CARTER WATKINS ASSOCIATES ARCHITECTS, INC.

DATE: August 28, 2023
TO: **ALL BIDDERS**
RE: **Jackson County Animal Shelter**

ADDENDUM #1

SHEET TITLE: FOUNDATION NOTES AND DETAILS
NUMBER: S-002
PRINTED:

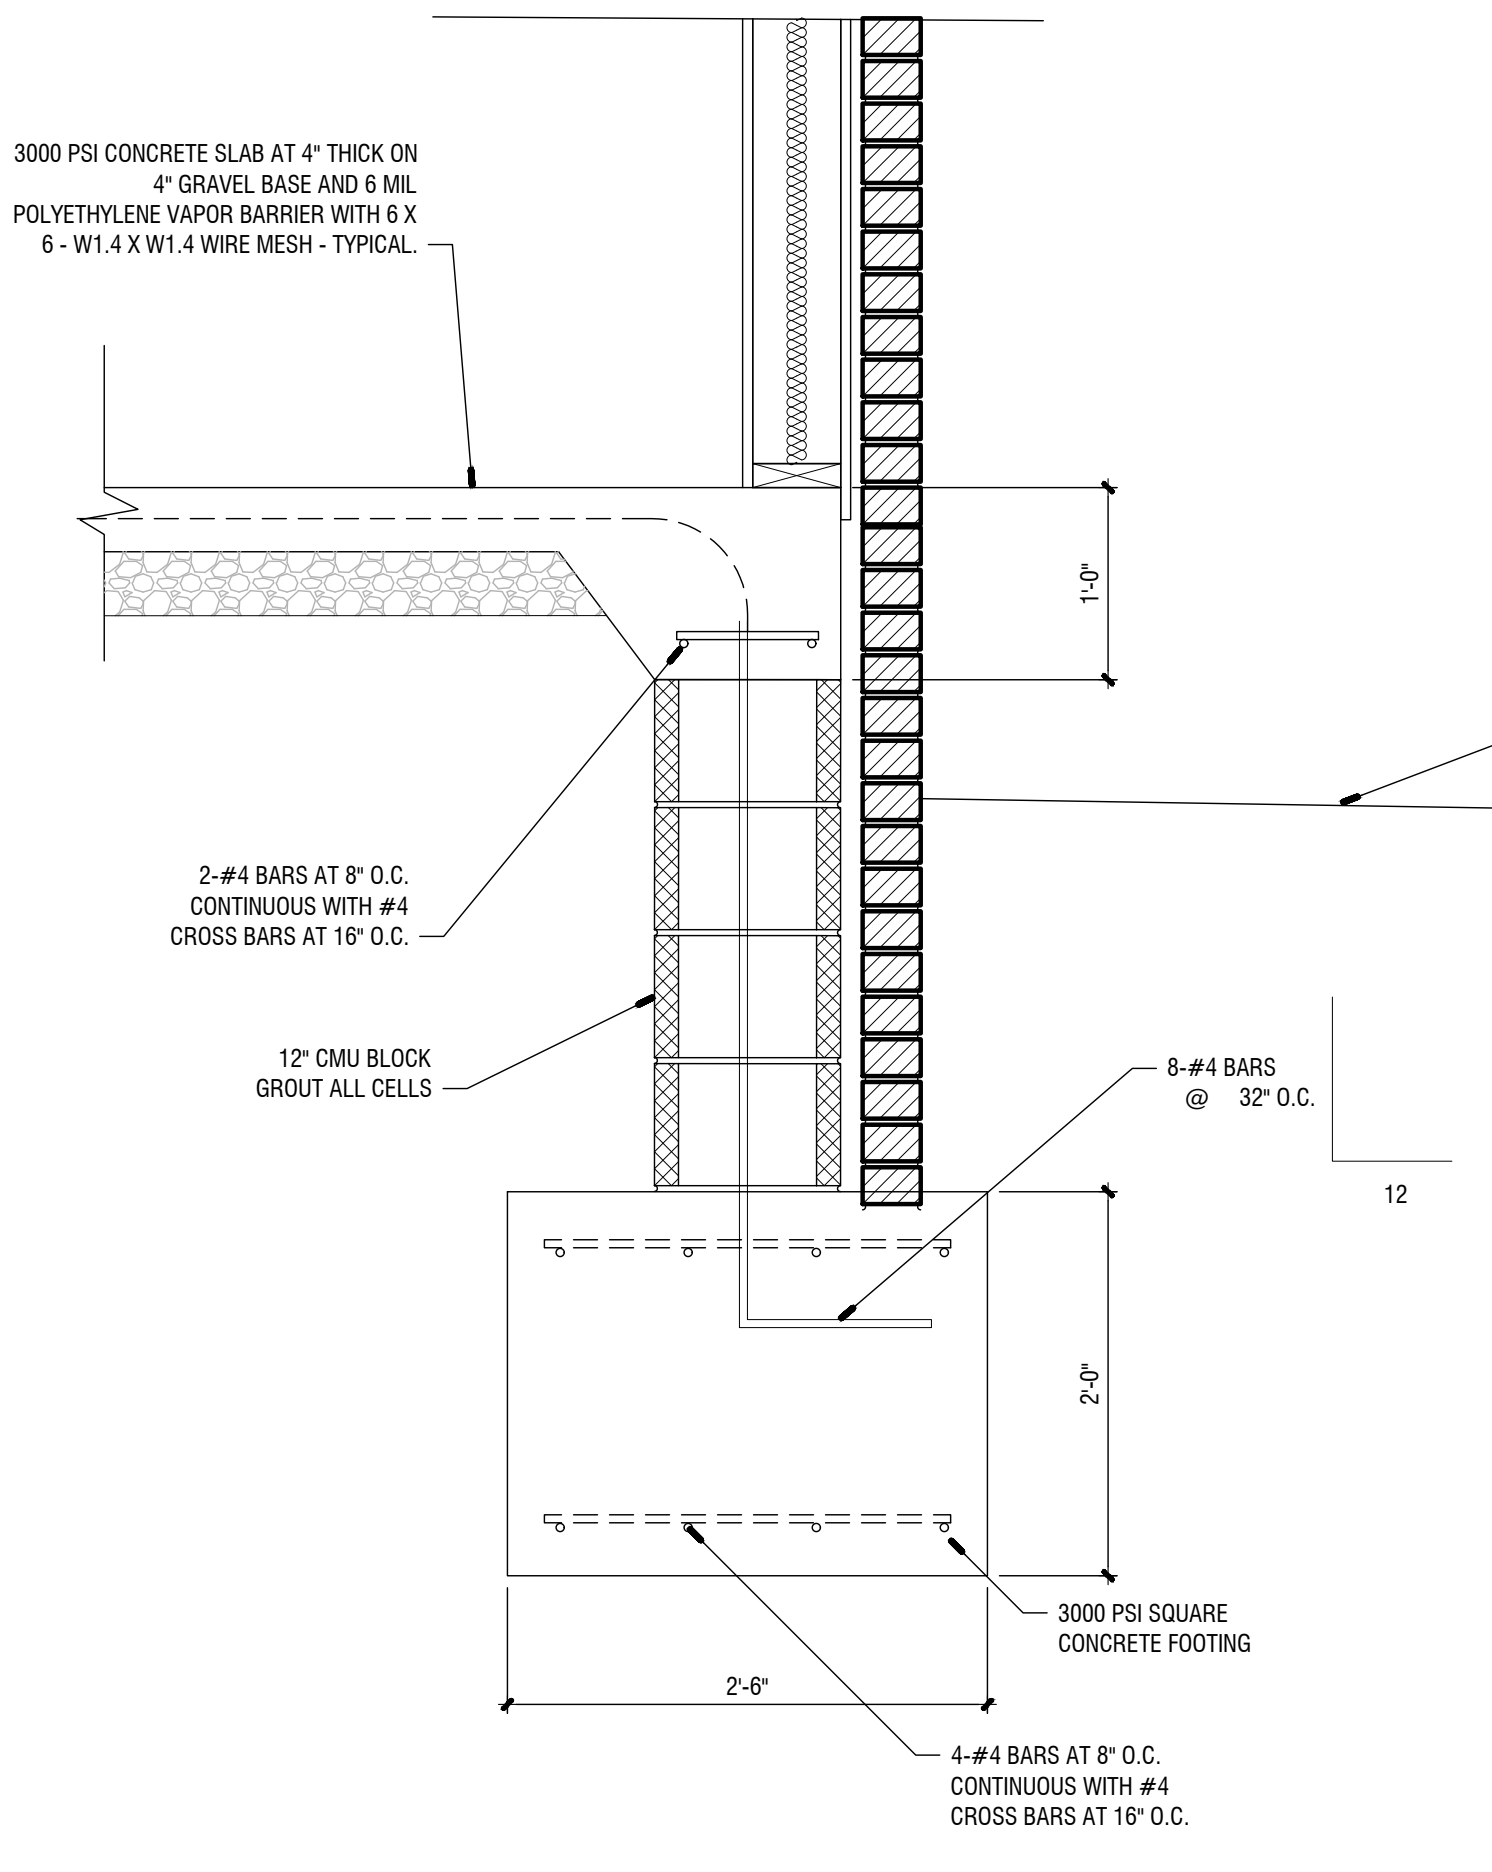
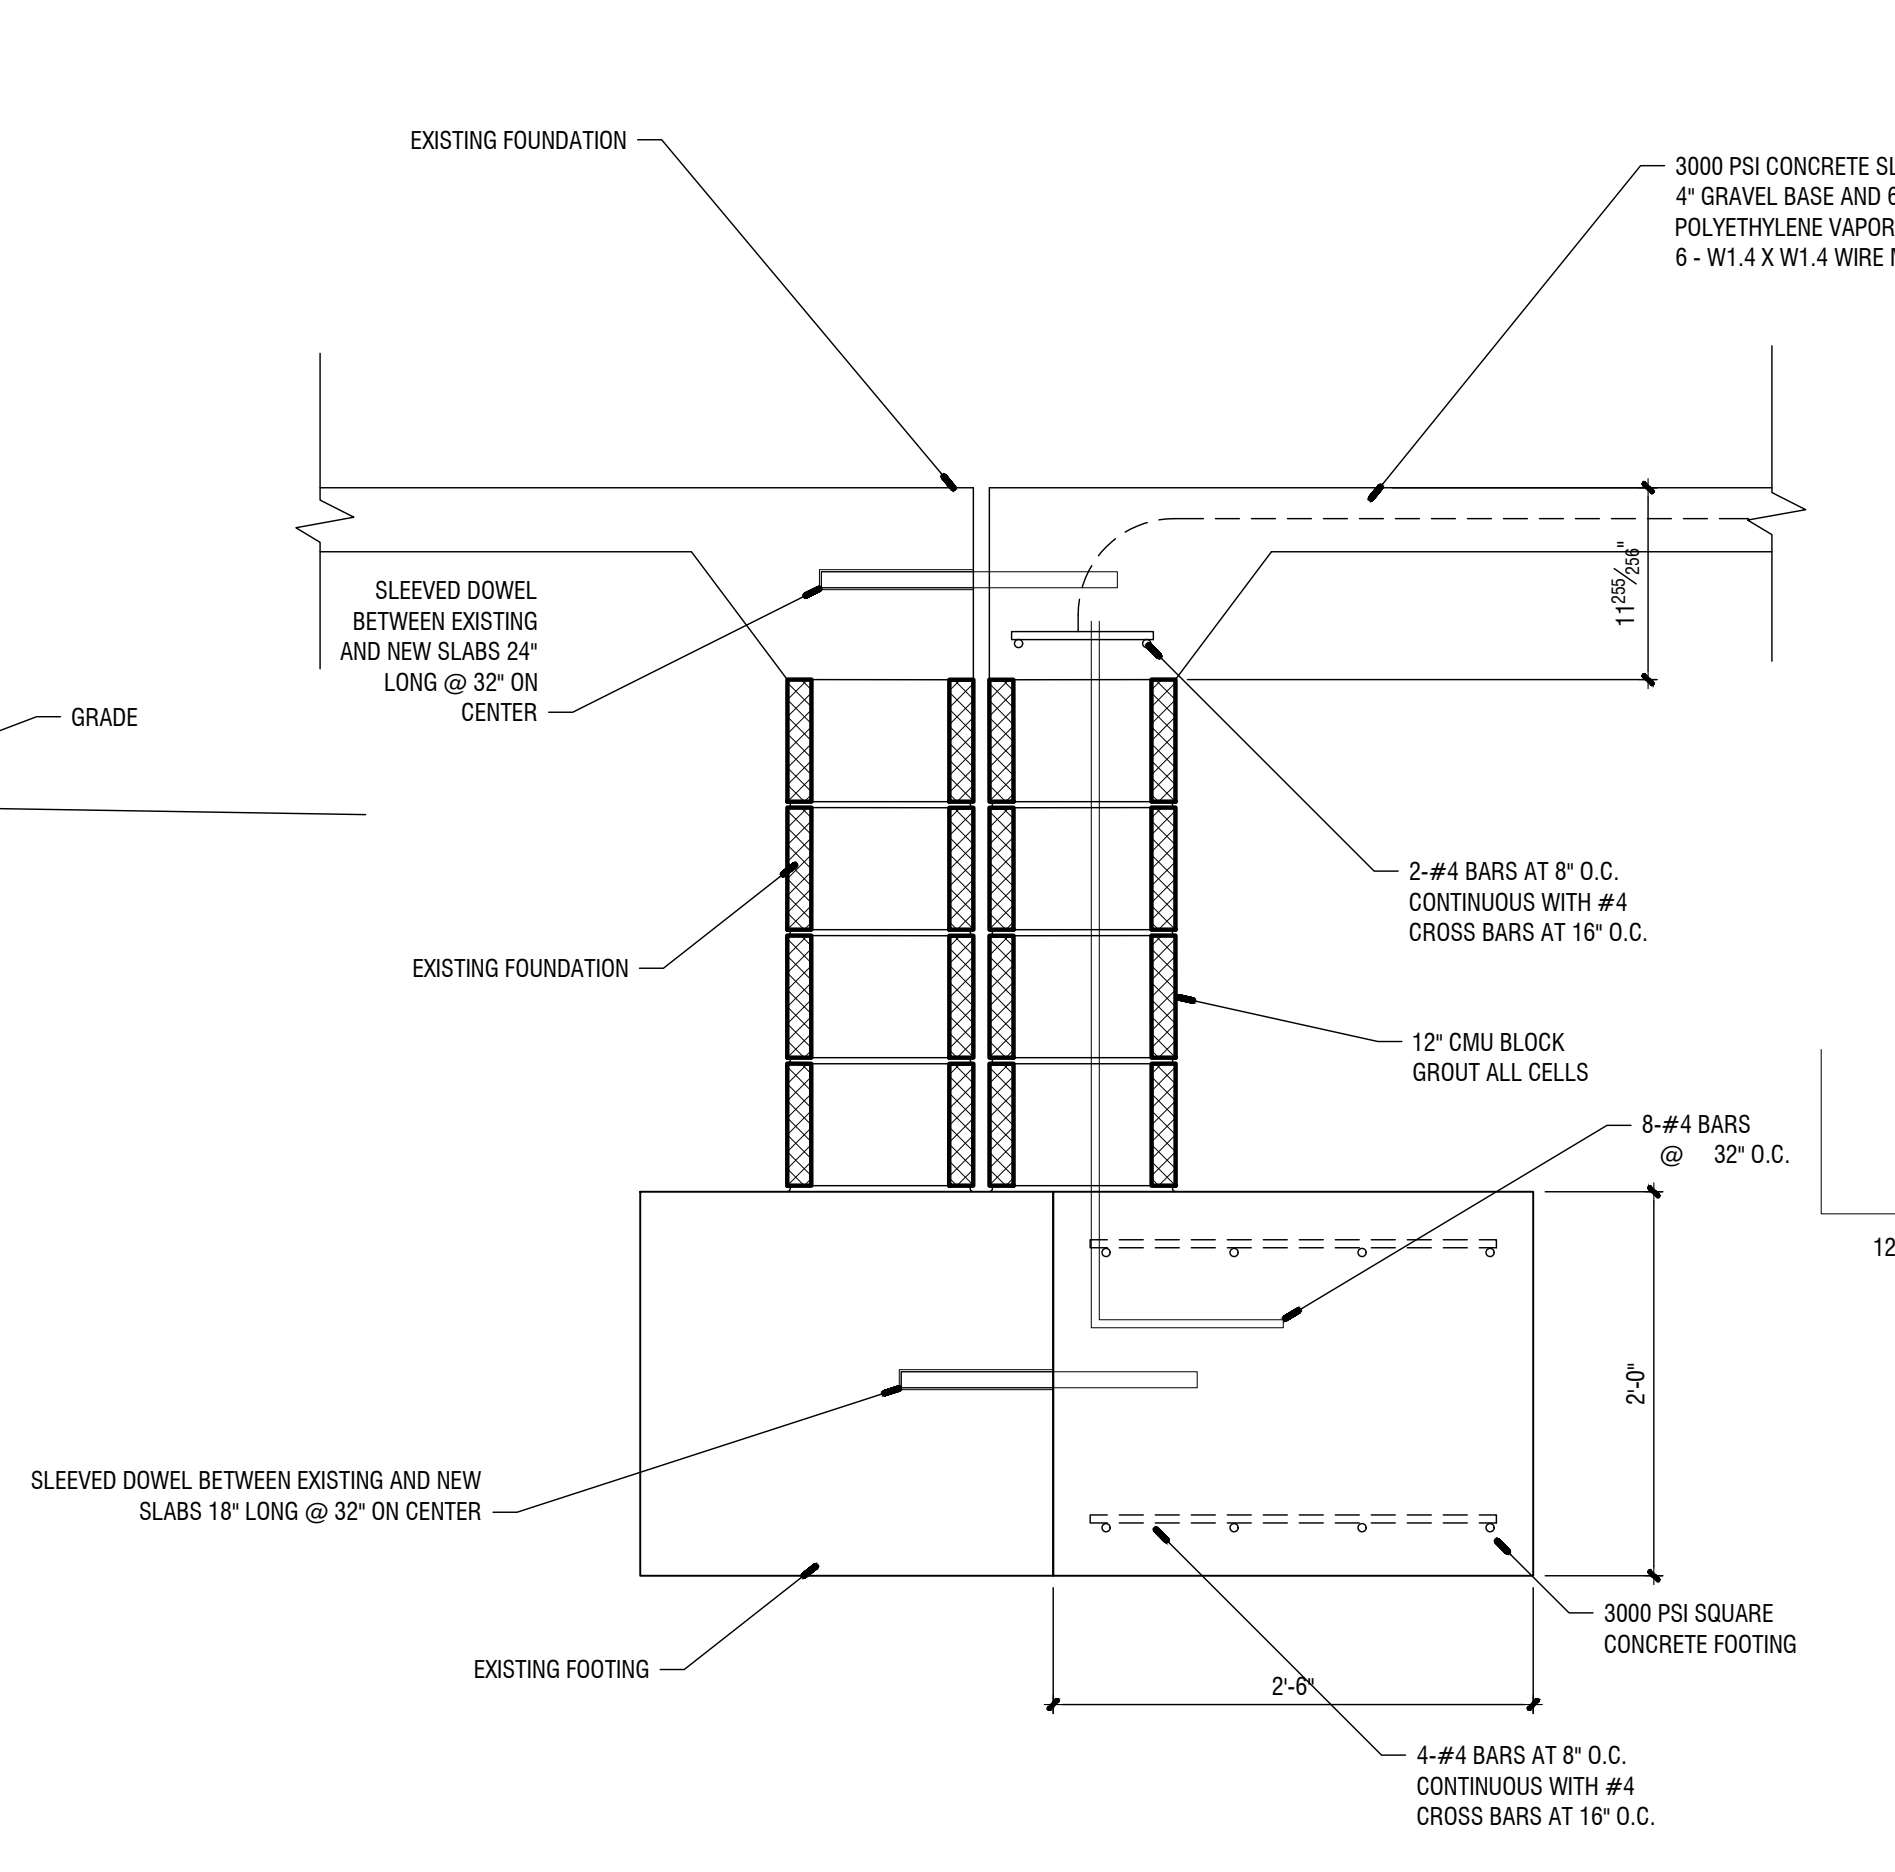
3. See the attached revised E-3 sheet.
4. See the attached revised S-001 & S-002 drawings.
5. See supplemental sheet AA-01 with notes for Alternate Add #1 Walk-in Freezer/Cooler.
-New cooler/freezer manufacturer to be Southeast Cooler or as equal.

| REVISIONS | | | CONSULTANTS | | |
|-----------|---------|-------------------------|-------------|------|---------|
| 1 | 8.28.23 | REVISED FOUNDATION DWGS | | | |
